**CITY OF VANCOUVER  
DEVELOPMENT, BUILDINGS, & LICENSING**

**DEVELOPMENT PERMIT STAFF COMMITTEE  
MEETING  
February 5, 2019**

**128 E Cordova Street (COMPLETE APPLICATION)  
DP-2019-00895 – HA-2**

**Figure 3: Project Site in relation to wider block (East Cordova Street Elevation)**

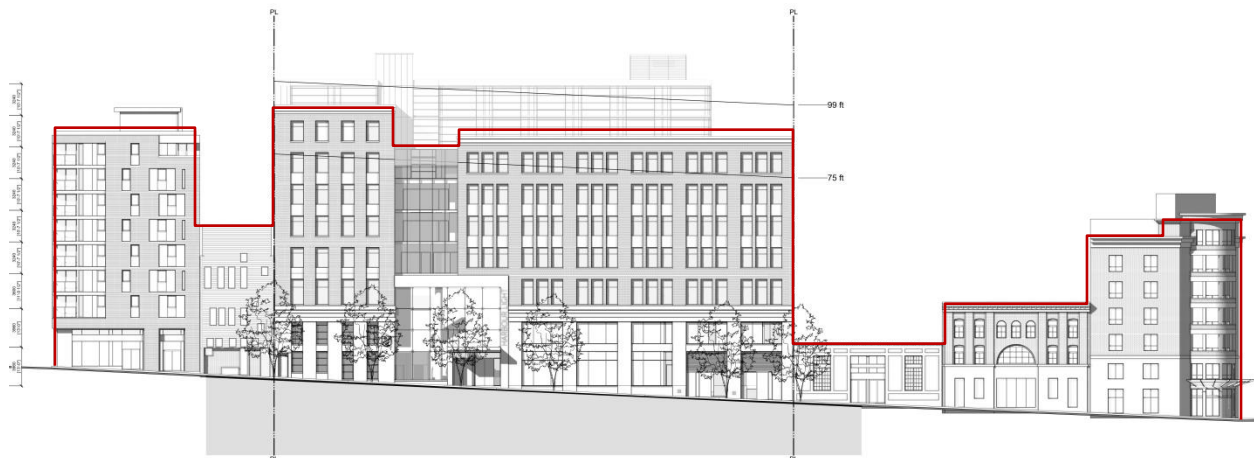
- **Height, Density and Composition:** The additional floors beyond the 22.9 m [75 ft.] height limit are recessed from the front wall plane and of a different material so as to allow the masonry volumes to stand as the dominant structures on the block. Evoking Section 4.3.2, this height increase can be considered as it meets the criteria outlined. The massing, expressed as two different volumes with different widths and heights, reinforces the sawtooth profile common in the area.

Staff are generally supportive of the height and the massing which is split into two distinct volumes to align better with the finer grain fabric of the area. The uppermost storeys are set back to reduce appearance of height. The massing meets many of the urban design objectives in the HA-2 District Schedule and Guidelines. Staff will be seeking approval from the Development Permit Board to grant this height increase. However, subsequent development of the application should be supplemented with shadow studies to demonstrate how the additional height up to 32.74 m [107.4 ft.] differs from the typical 22.9 m [75 ft.] limit in terms of shadowing on the north sidewalk on East Cordova Street.

Planning Staff are supportive the general directions taken here for the composition of the East Cordova Street facing facades. However, the HA-2 District Schedule and Guidelines, and Downtown Eastside Plan mention Indigenous place-making through new developments, and this is not evident in this submission. As such, Planning Staff will recommend further design development to the East Cordova Street elevation by strengthening the expression of the masonry volumes and the fenestration composition within them. Additionally, a degree of

“lightness” for floors above the masonry volumes should be maintained. The HA-2 Guidelines recommend more robust window-frames comparable to traditional make. Wood or metal should be used, and window frames and panes should be set in about 100 mm [4 in.] away from the front wall plane to enrich the façade through shadow-lines and play of different depths.

Planning Staff are generally supportive of the ground-level and public realm treatment. However, further refinement could be introduced to the main entry to improve wayfinding. This may be considered together with Indigenous place making.

- Recommended Condition 1.2 is to refine the East Cordova Street elevation, particularly to give prominence to the two masonry volumes as the key blocks that form the streetscape;
- Recommended Condition 1.3 seeks refinement to the lane-side treatment; and
- Recommended Condition 1.5 seeks further shadow analysis.

**Figure 4: Interior Elevation**  
The red-outlined denotes the lightwell area.

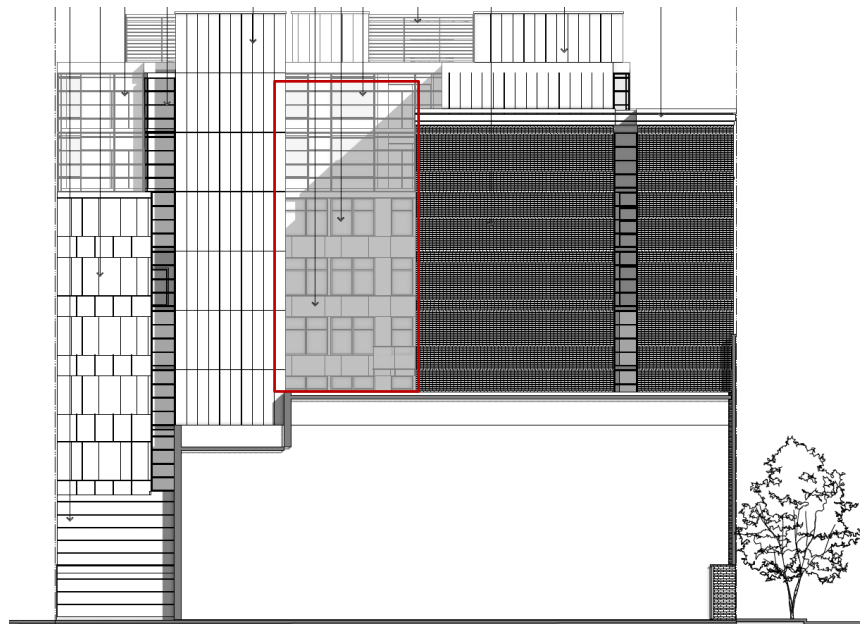
- **Livability:** Planning Staff noted that some of the lightwell-fronting rooms on the third, fourth and fifth floors may not receive direct natural light due to the width of the lightwell. However, Staff also recognised that the rooms on these floor floors are short-term stay where the residents may stay there for as little as one-day. The longer term residences located on the upper-floors will have adequate access to natural light. As such, Staff are supportive of this configuration for the lightwells and room-placement. However, slight adjustments can be made to further improve livability.

- Recommended Condition 1.4 seeks refinement on livability issues.
